Amendment 39-2914; **AD 77-12-01**

Airworthiness Directives; Piper Models PA-28-235, PA-32-260, PA-32-300, and PA-32S-300 Airplanes  
DATES: Effective June 10, 1977.

**77-12-01 PIPER AIRCRAFT CORPORATION:** Amendment 39-2914. Applies to Models PA-28-235, PA-32-260, PA-32-300, PA-32S-300 airplanes certificated in all categories. Models and serial numbers of airplanes affected are noted in sections (a), (b), (c), (d), and (e) in the body of the A.D.

## TIP TANK VENT TUBE

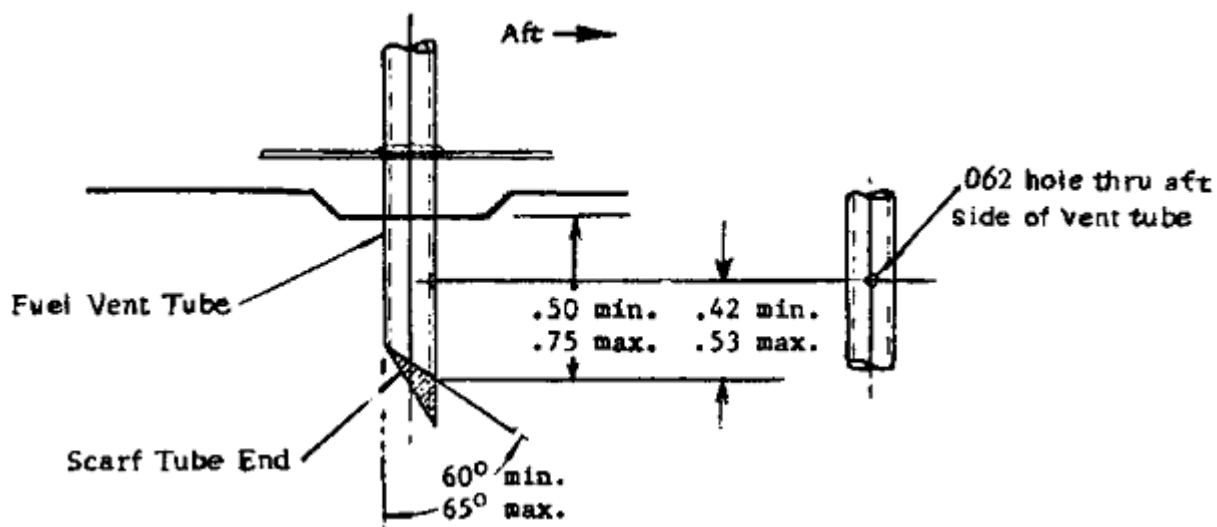
(1) Unless already accomplished, rework fuel tip tank vent to the dimensions shown on the sketch below:

NOTE: Some tip tanks were not equipped with protruding external vents, and (d)(1) of the A.D. does not apply to those tanks.

(4) If the tip tank vent tube scarf angle is not between 60 degrees and 65 degrees, or if the vent tube is not perpendicular (90 degrees) plus or minus 2 degrees, rework it to those dimensions.
